ROOSEVELT ELEMENTARY SCHOOL MODERNIZATION

2324 VERDE STREET
FOR
BAKERSFIELD CITY SCHOOL DISTRICT
BAKERSFIELD, KERN COUNTY, CALIFORNIA

TITLE SHEET, SHEET INDEX & VICINITY MAP

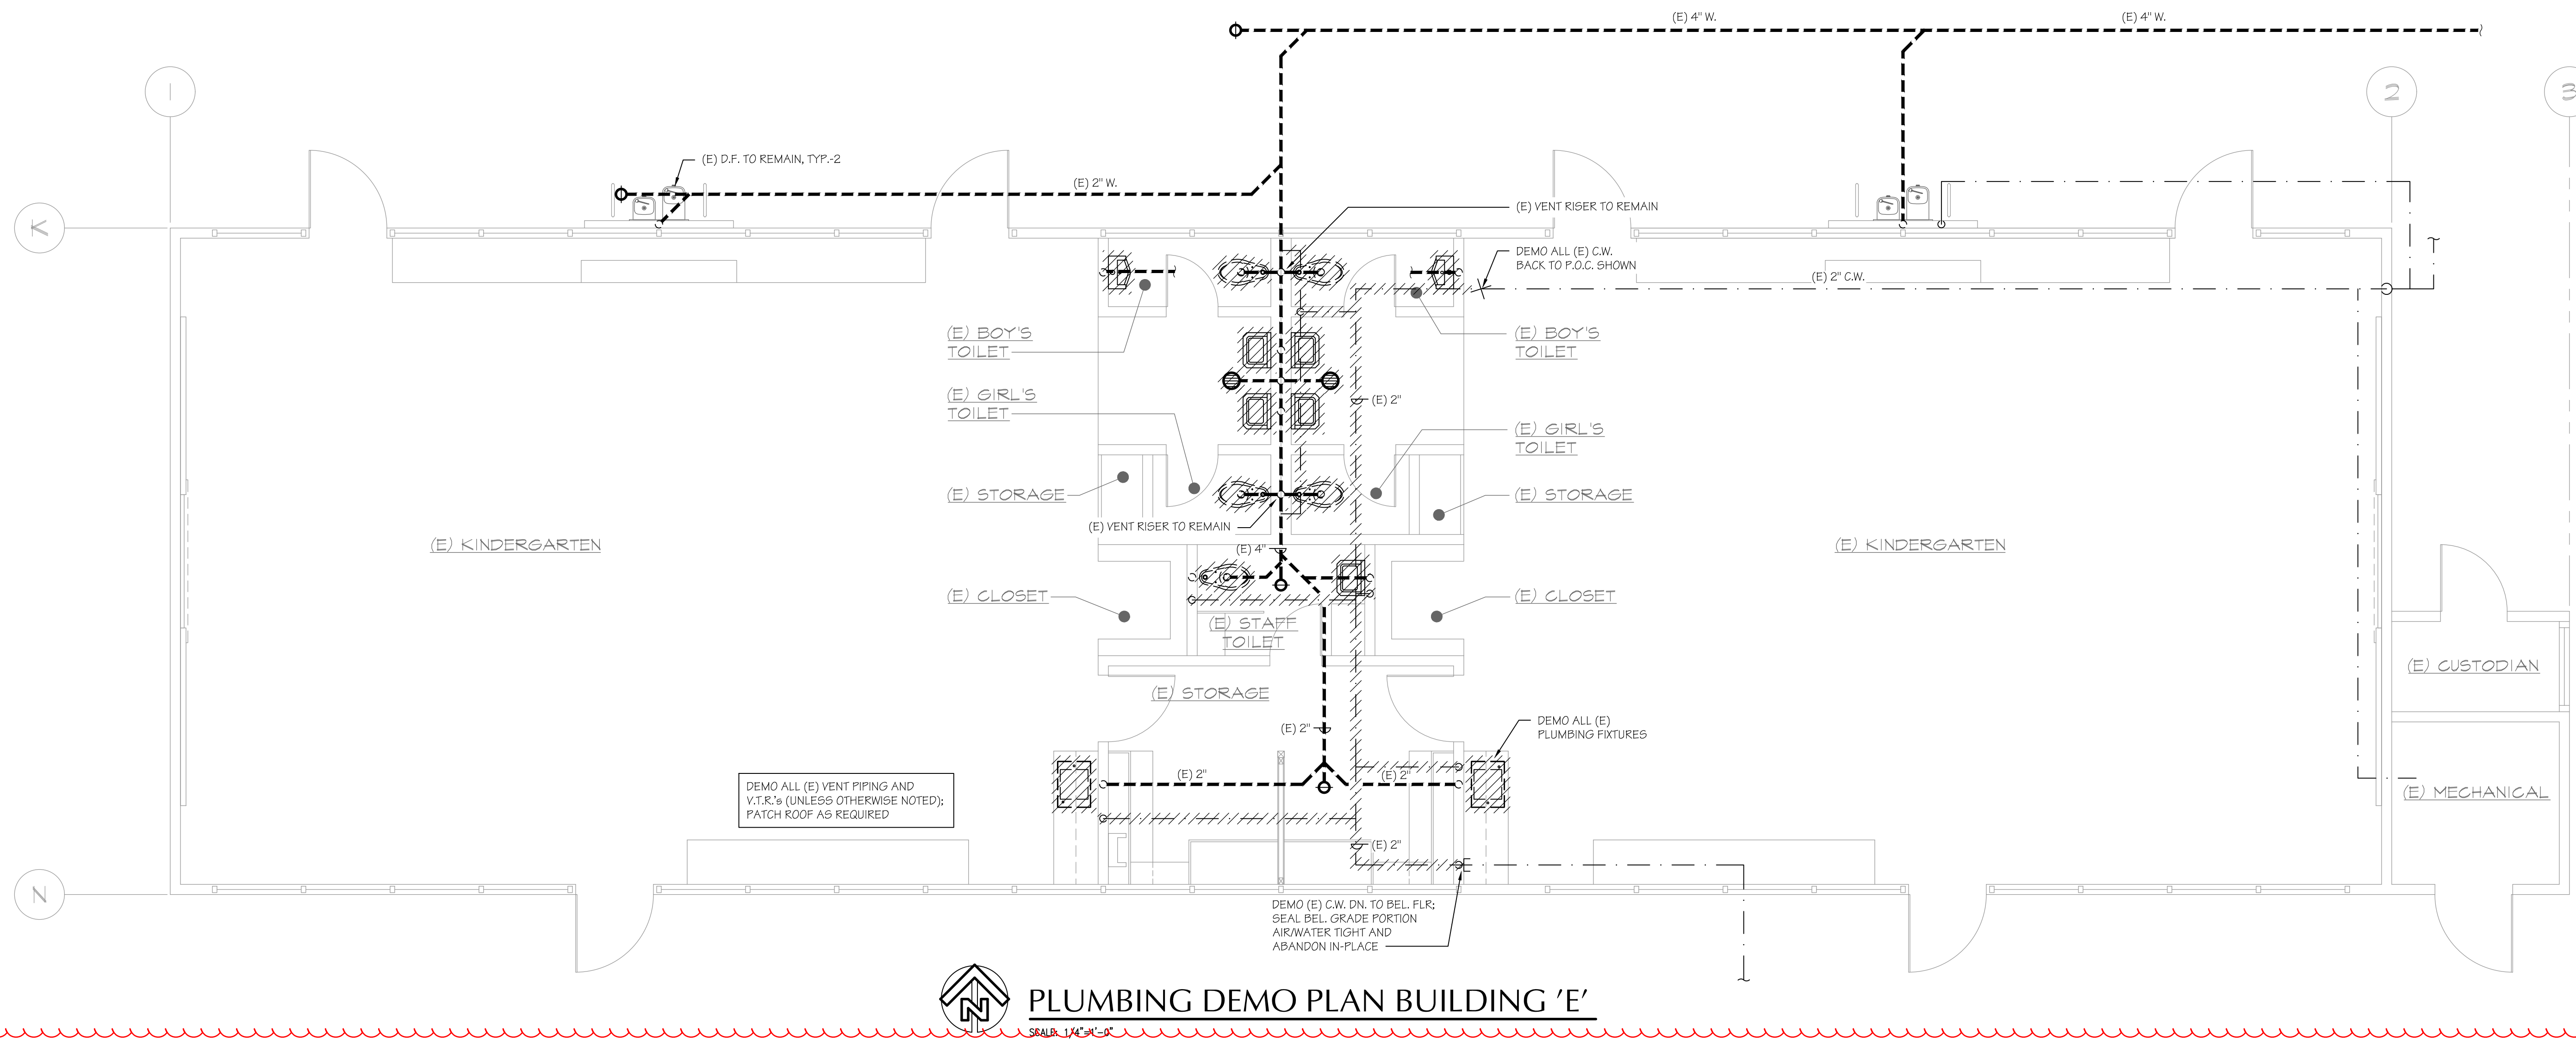
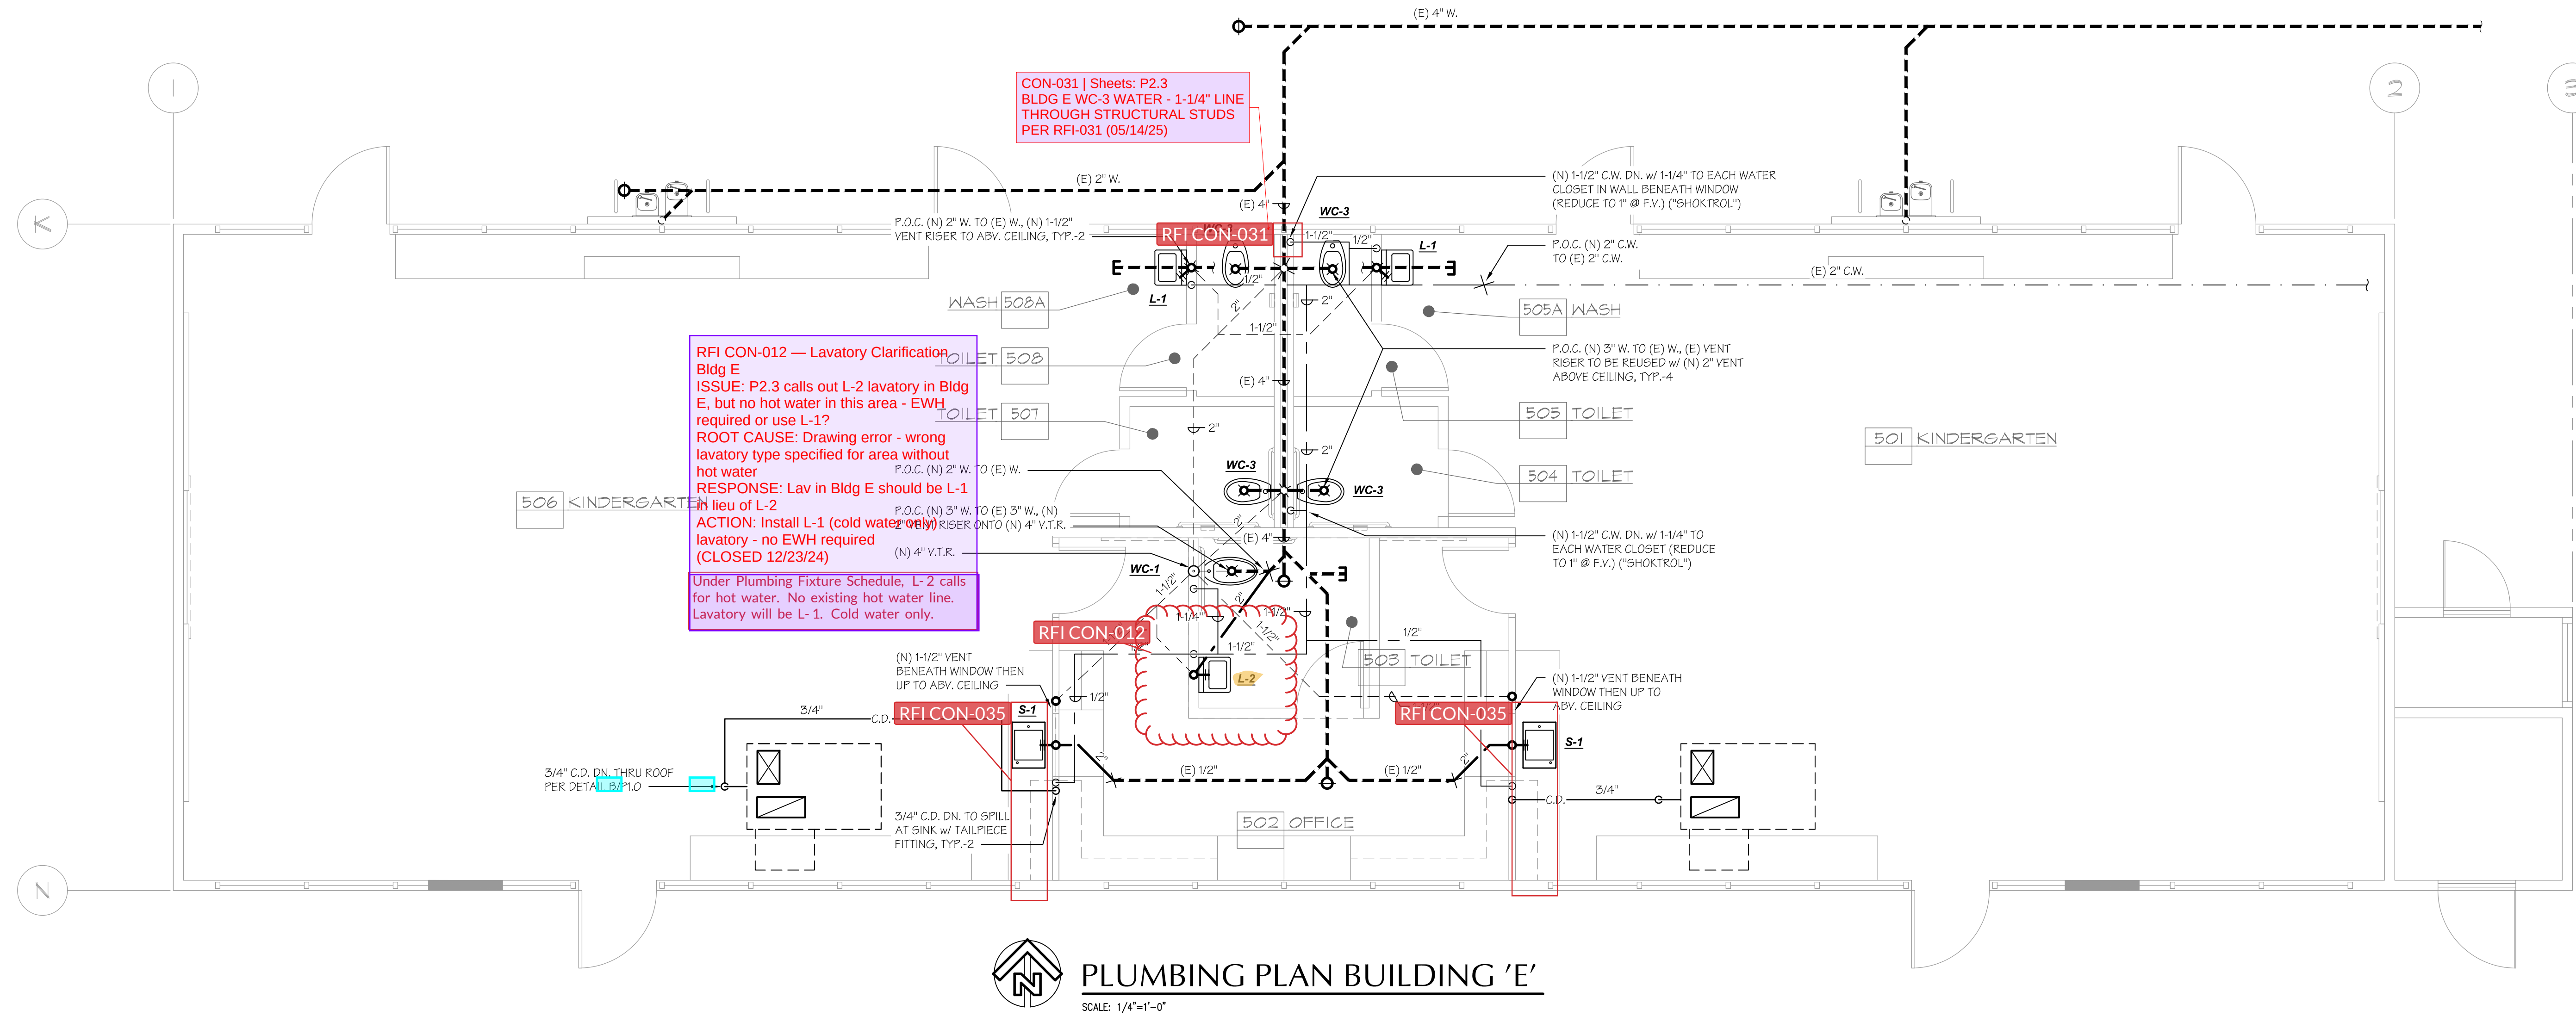
CON-035 | Sheets: P2.3
CABINETS AT 501 & 506
PER RFI-035 (06/20/25)

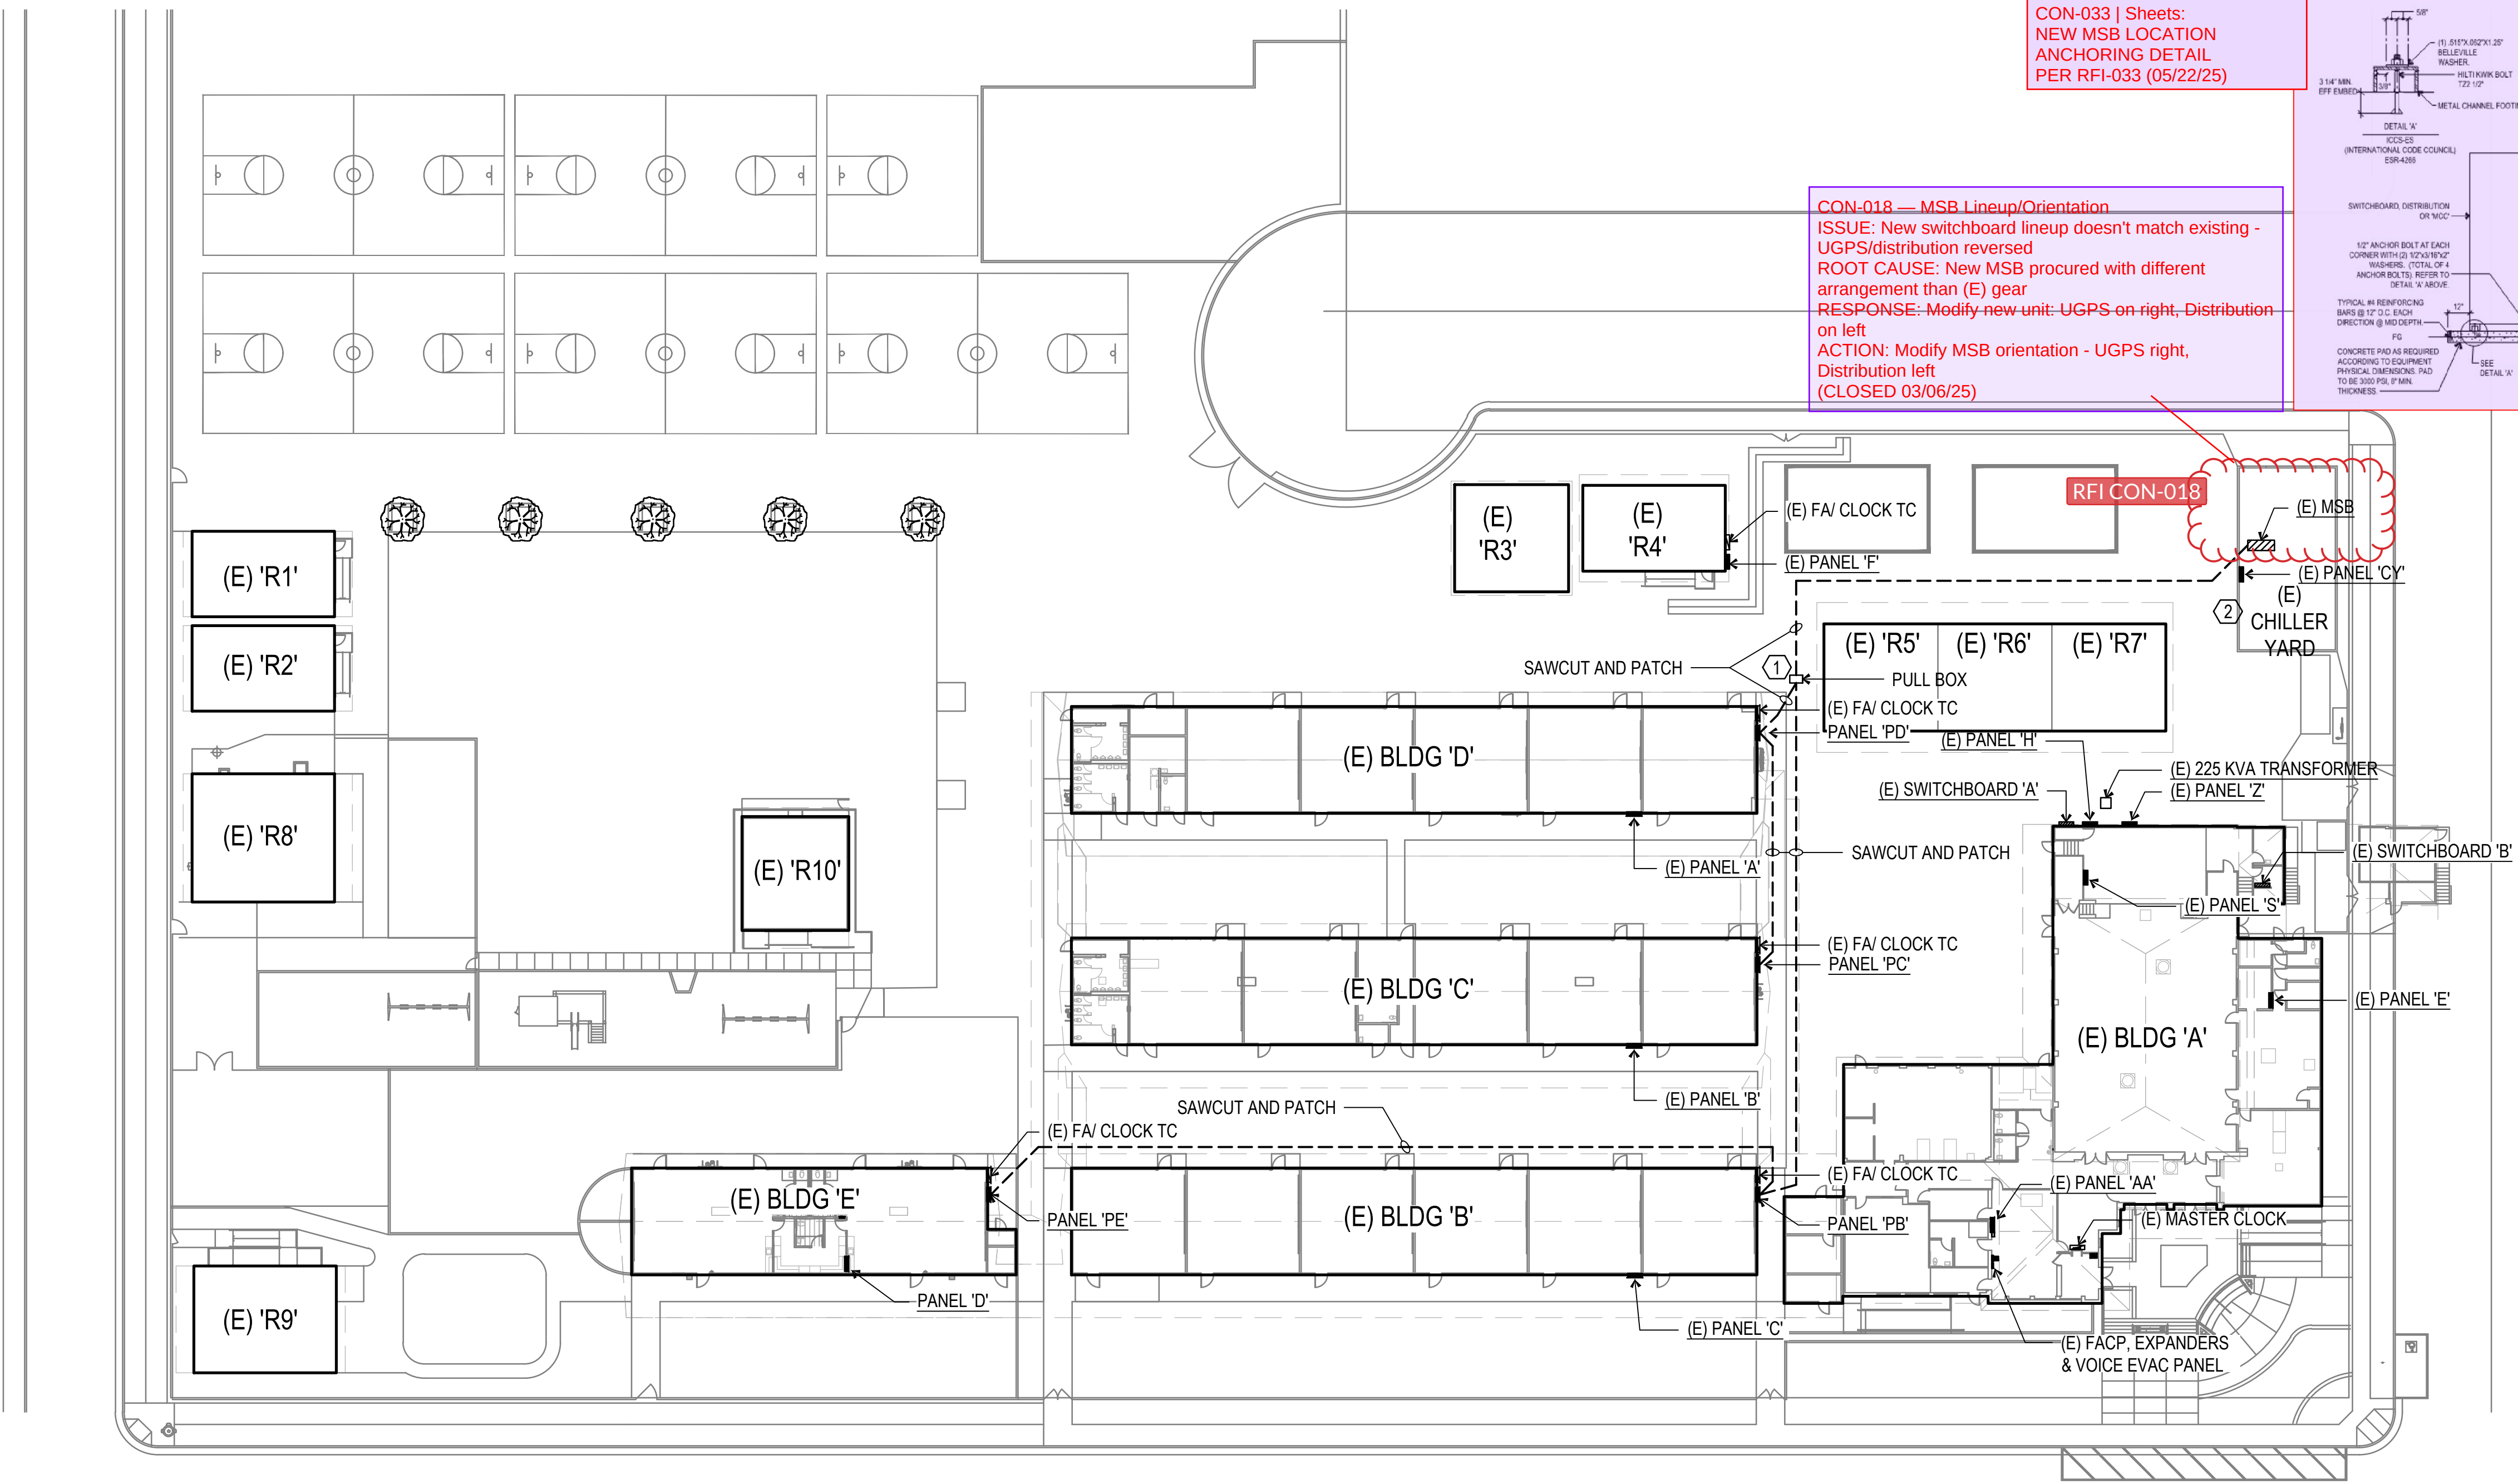
CON-033 | Sheets:
NEW MSB LOCATION
ANCHORING DETAIL
PER RFI-033 (05/22/25)

CON-018 — MSB Lineup/Orientation
ISSUE: New switchboard lineup doesn't match existing - UGPS/distribution reversed
ROOT CAUSE: New MSB procured with different arrangement than (E) gear
RESPONSE: Modify new unit: UGPS on right, Distribution on left
ACTION: Modify MSB orientation - UGPS right, Distribution left (CLOSED 03/06/25)
